FINAL PLAT
HAWTHORNE THIRD ADDITION
AN ADDITION TO WICHITA, SEDGWICK COUNTY, KANSAS

RE: SUB 2004-33 -- Final Plat of Hawthorne Third Addition

At the regular meeting of the Subdivision Committee of the Metropolitan Area Planning Commission on Thursday, May 13, 2004, the above captioned plat was considered. The action of the Committee was to approve the final plat, subject to the following staff comments:

CASE NUMBER: SUB 2004-33 -- HAWTHORNE THIRD ADDITION

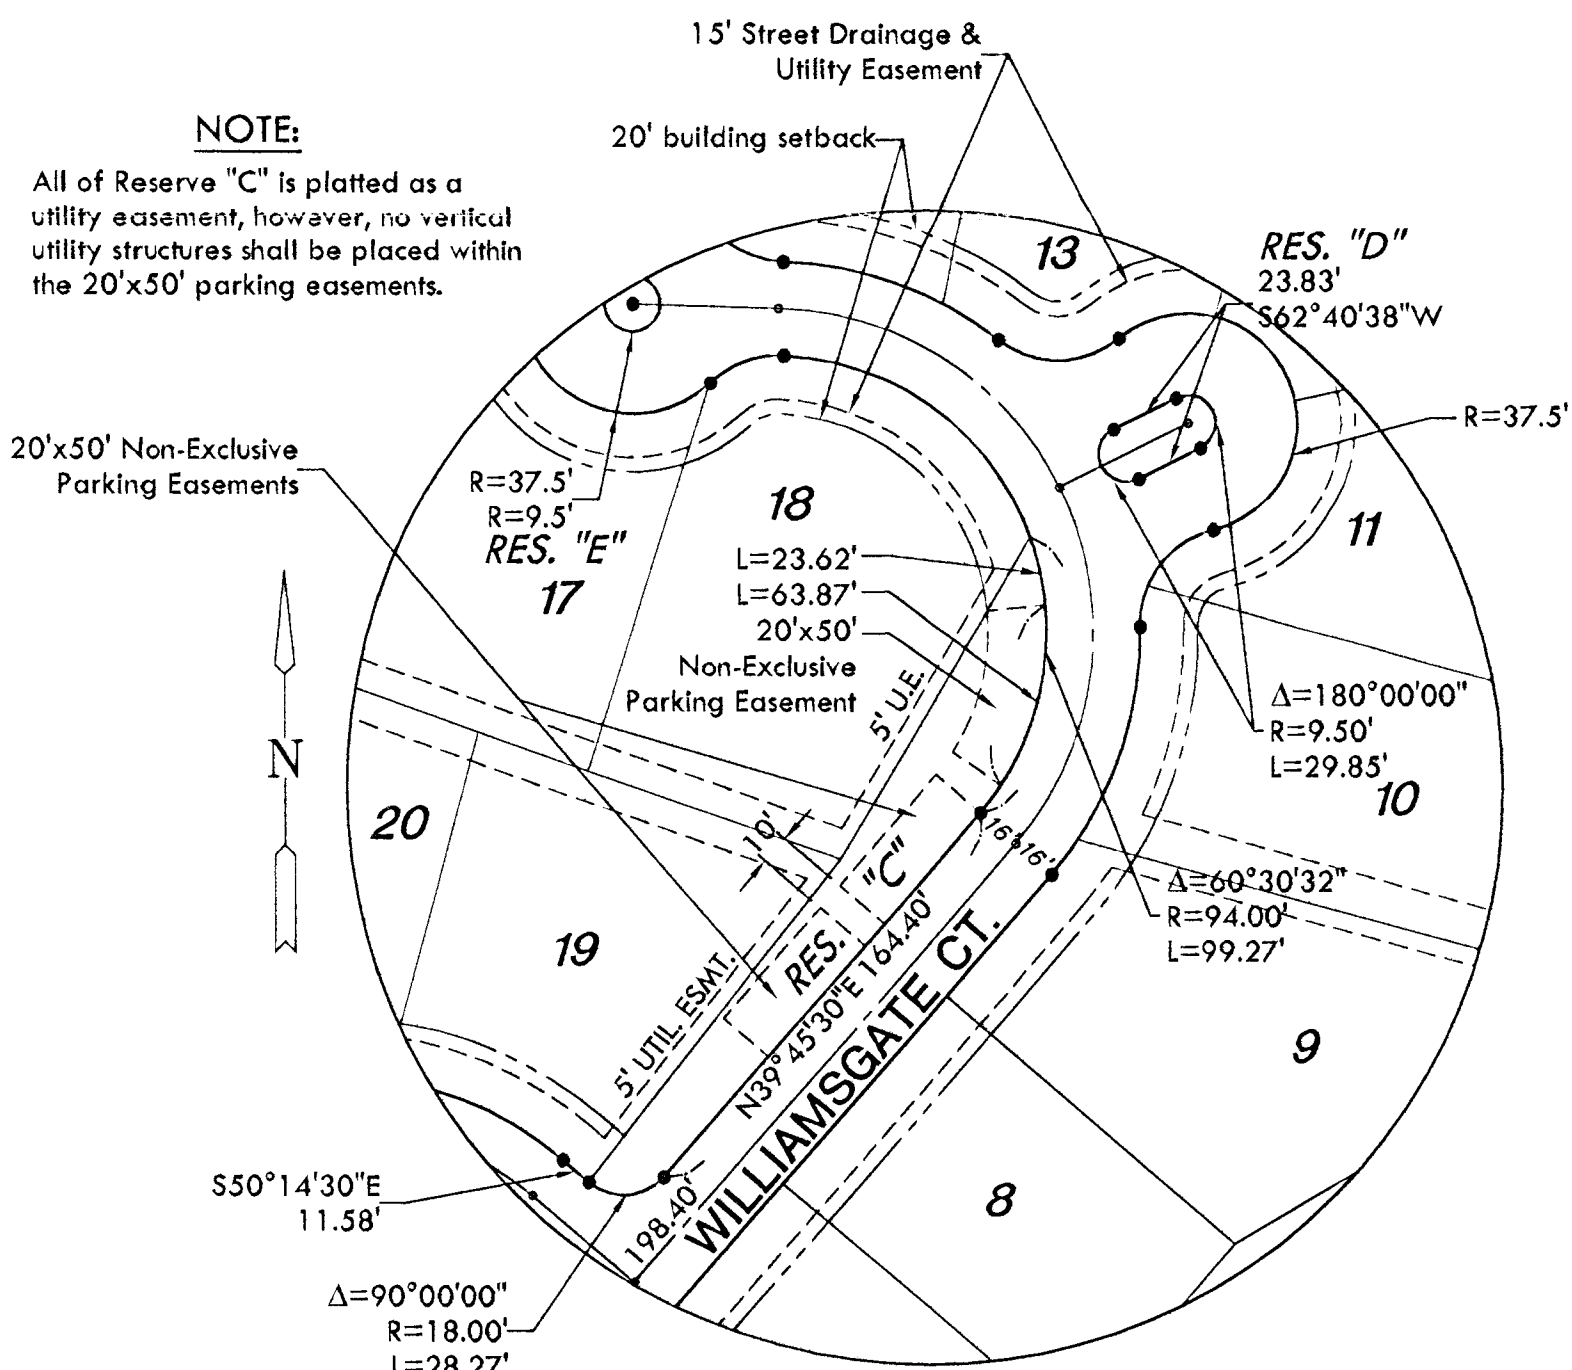
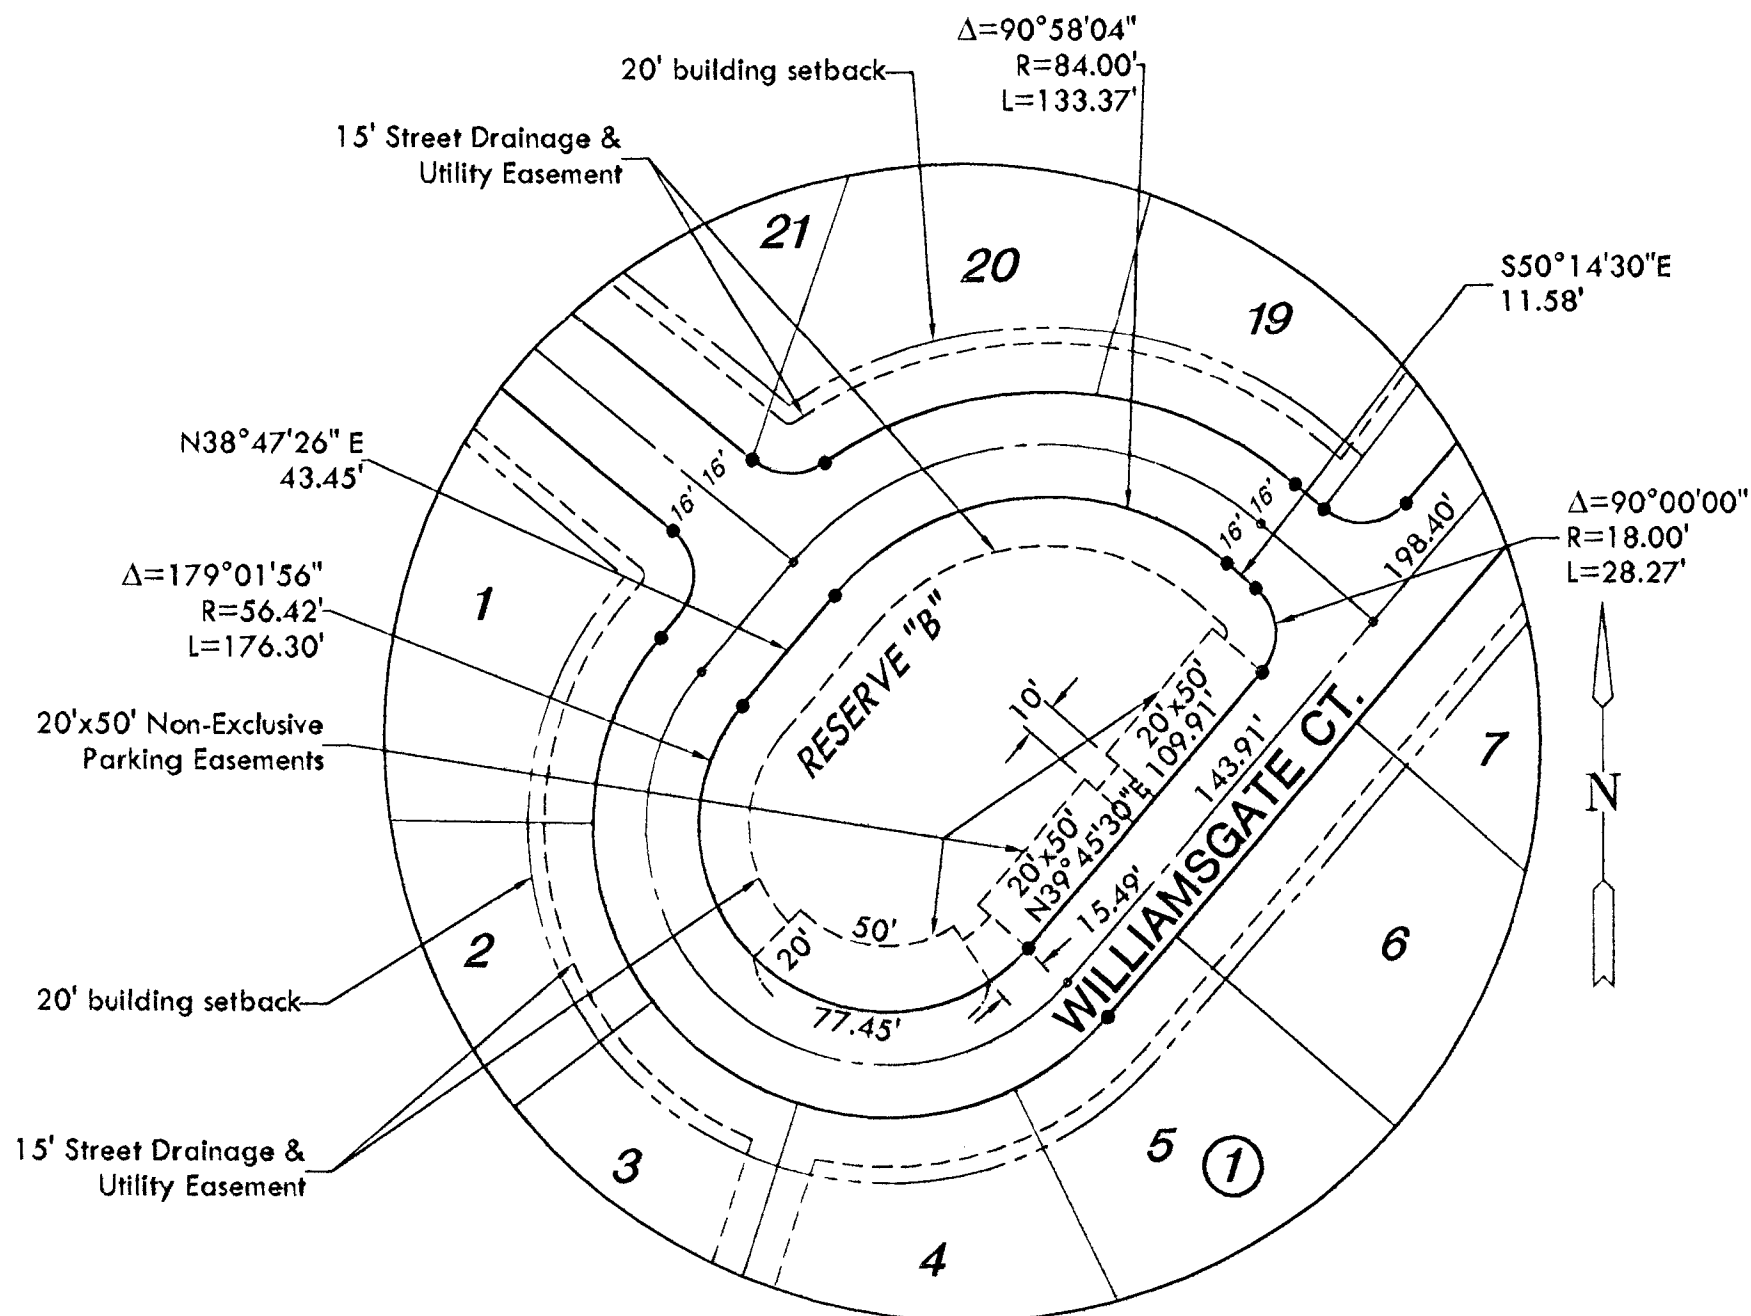
- F. The parking easements need to be labeled. Their reference in the plat's text as being "hereby granted to the public" needs to be deleted.
- G. Enlargements of various "Details" indicated on the plat need to be included.

- H. Williamsgate Ct has been platted as a 32-ft narrow local residential street. A 15-ft street drainage and utility easement is needed along the street.

- O. GIS needs to comment on the plat's street names. *The street stub extending to the east - Camden Chase - needs to be labeled.*
- P. The signature line for the City Clerk needs to be revised to reference "Karen Sublett".

- R. The legal description needs to be revised to clarify "Part of Williamsgate, Camden Chase, and Mainsgate".
- S. The platting text shall include language that a drainage plan has been developed for the plat and that all drainage easements, rights-of-way, or reserves shall remain at established grades or as modified with the approval of the applicable City or County Engineer, and unobstructed to allow for the conveyance of stormwater.

- AA. The representatives from the utility companies should be prepared to comment on the need for any additional utility easements to be platted on this property. **Westar Energy and SBC have requested additional easements.**
